DESIGN REVIEW COMMITTEE

700 Doug Davis Drive
Hapeville, GA 30354

May 17, 2023 6:00 PM

AGENDA

REVISED SIDE ELEVATION

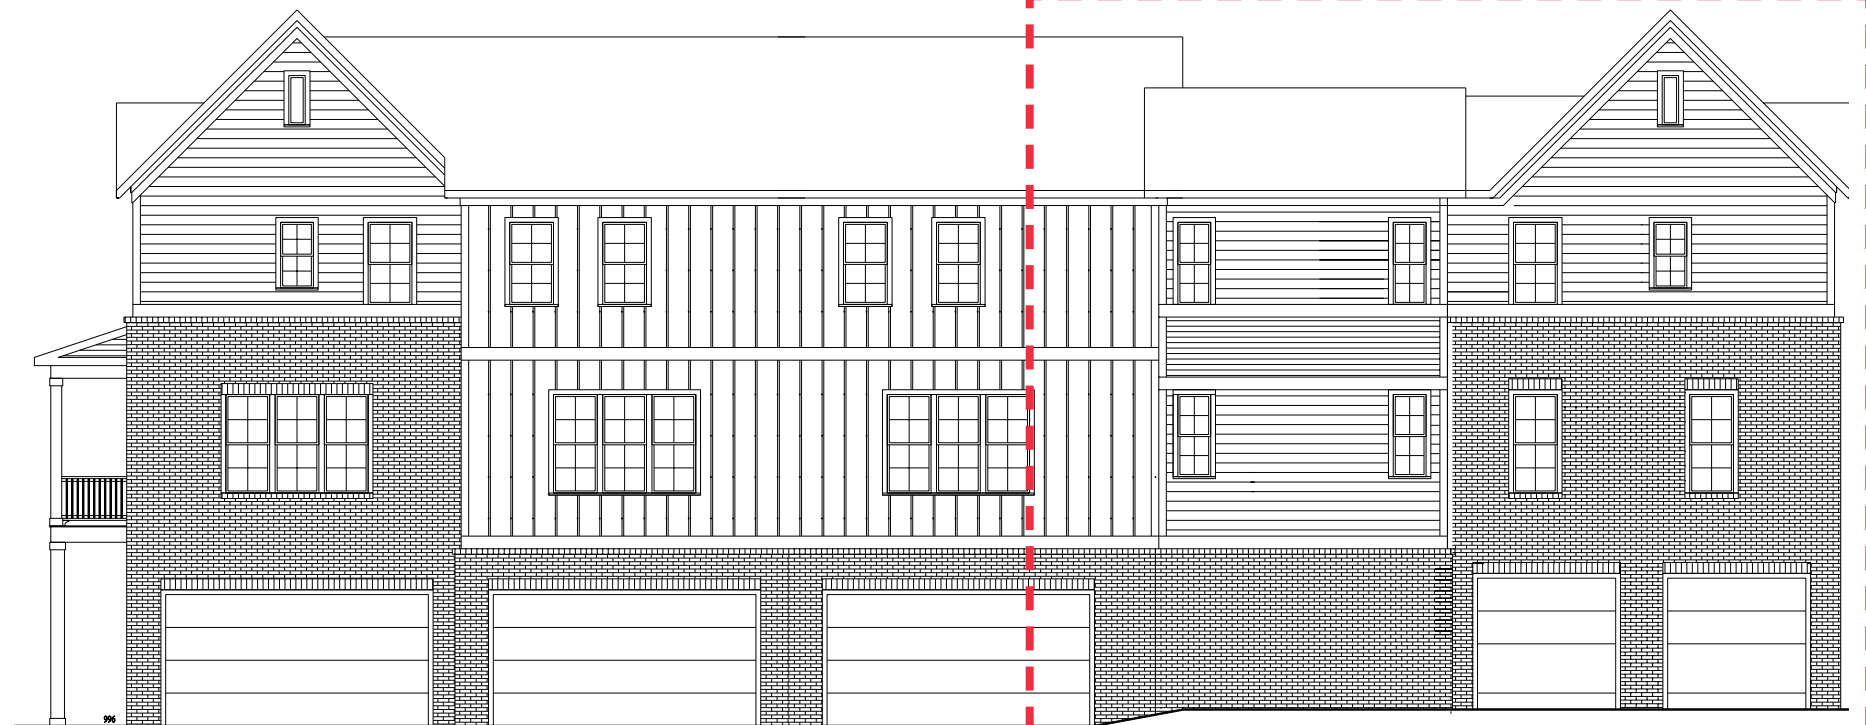
The City of Hapeville received a request from Matt Vyverberg to modify the one interior single family attached townhome in Building D to accommodate an existing Georgia Power guy wire. The guy wire was not shown on Georgia Power's plans and require a 12' clear area. The modified layout pushes the front elevation back to accommodate for the required clearance. The applicant has indicated that substantial landscaping will be provided in the supplemental area. The elevations meet the requirements for the Neighborhood Conservation Area Standards. The side elevation for the end unit has been modified with window relocation.

1 FRONT COLVILLE ELEVATION
SCALE: 1/4" = 1'-0"

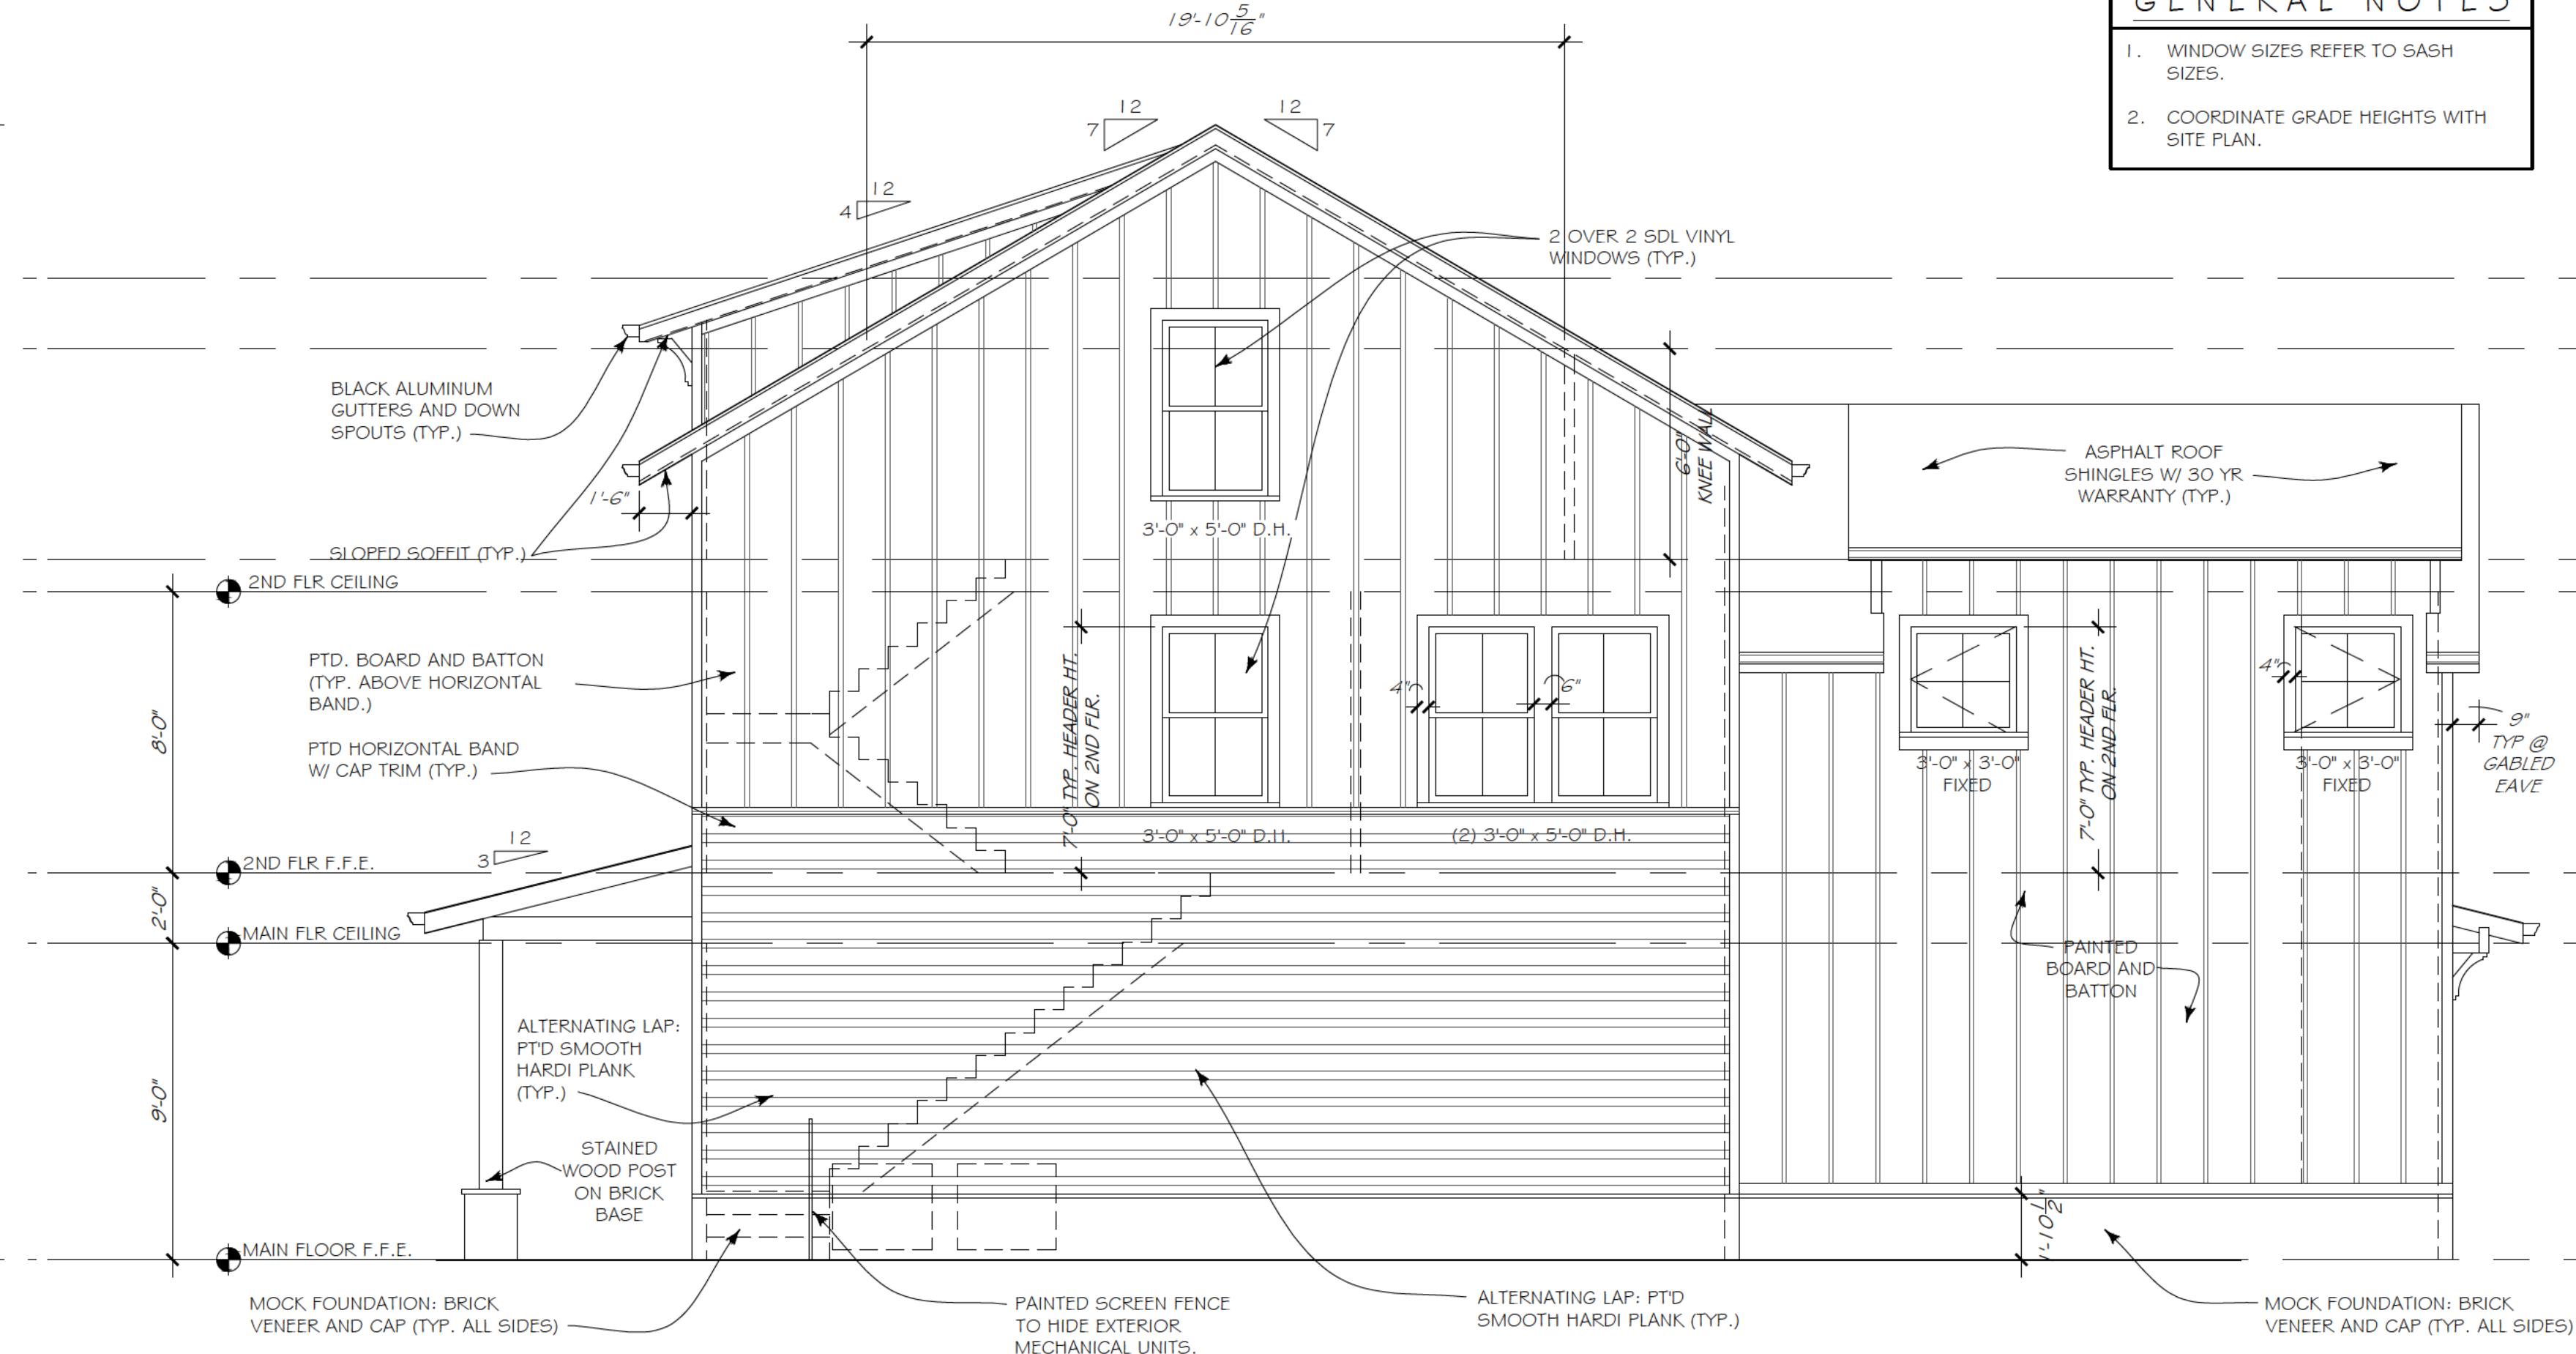
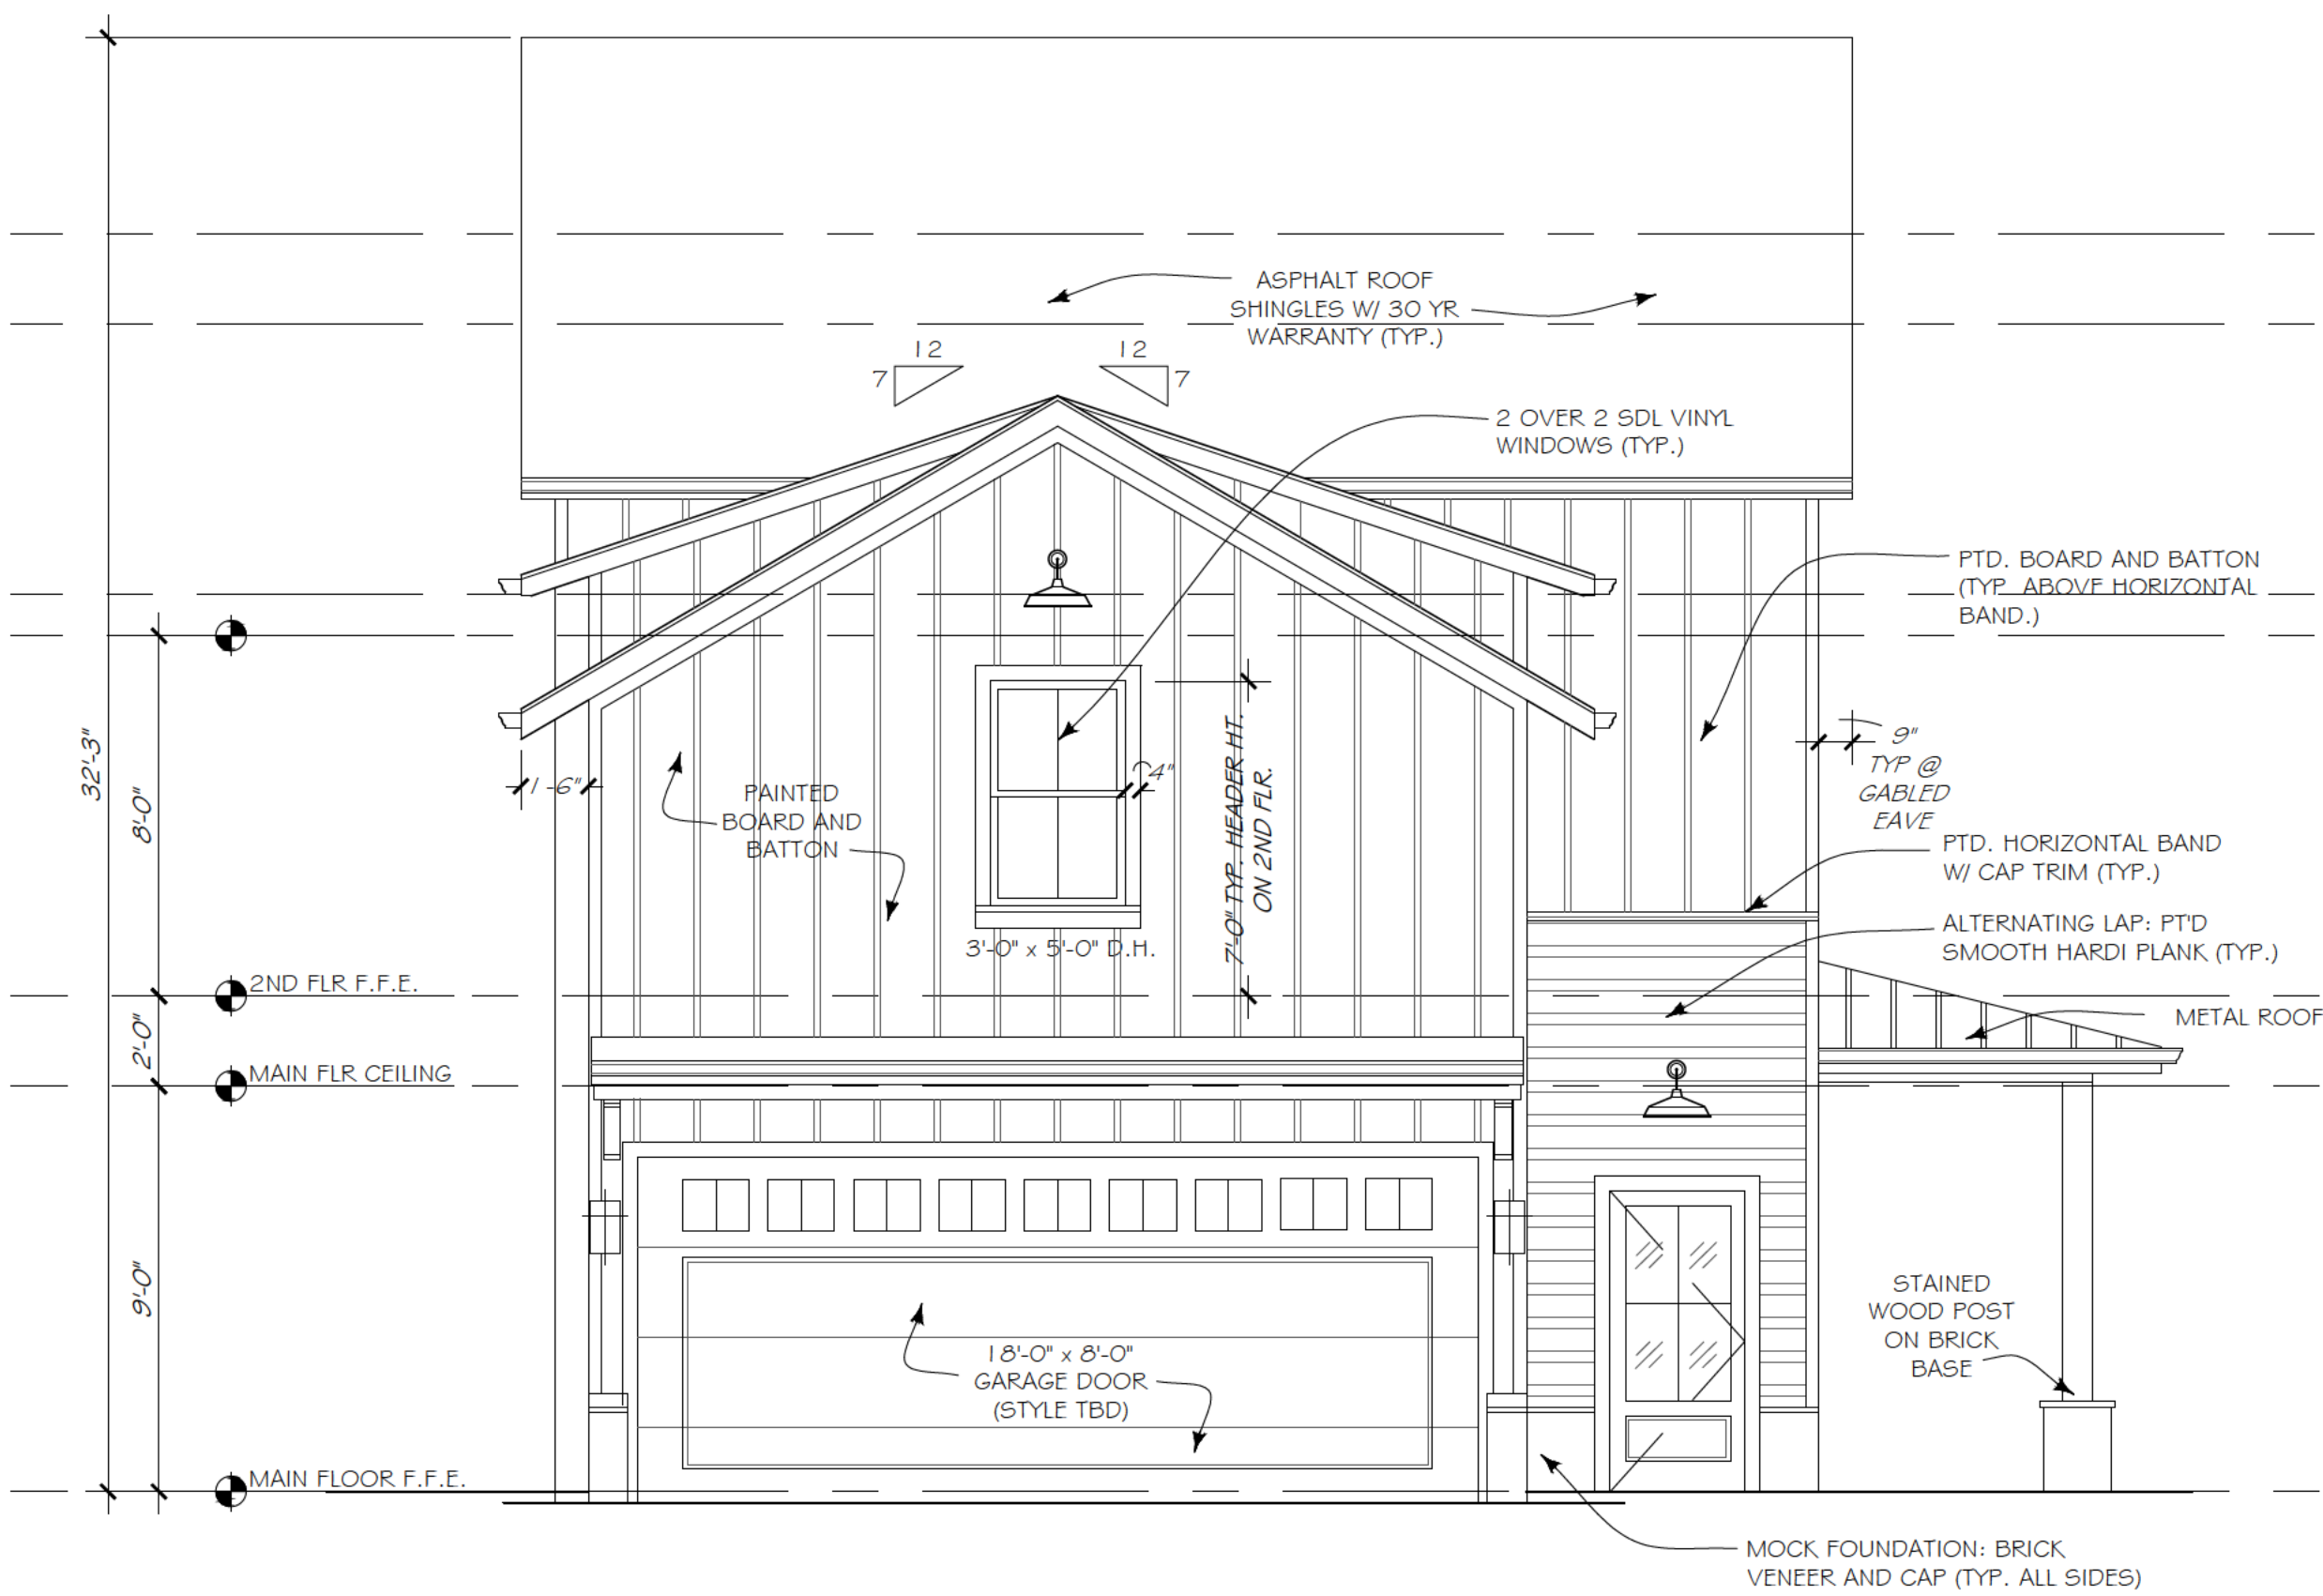
STAFF COMMENT: Windowless wall on 1st floor of side elevation. Stairs, kitchen and garage located on first floor. Design Exception Requested.

STAFF COMMENT: 2nd floor windows are approximately 21%.

- Updated site plan showing dwelling outside of the 15' setback.
- 2nd story windows are 21% of façade.
- Provide sill height
- Approved Tree Conservation Plan (submitted and under review by Arborist)
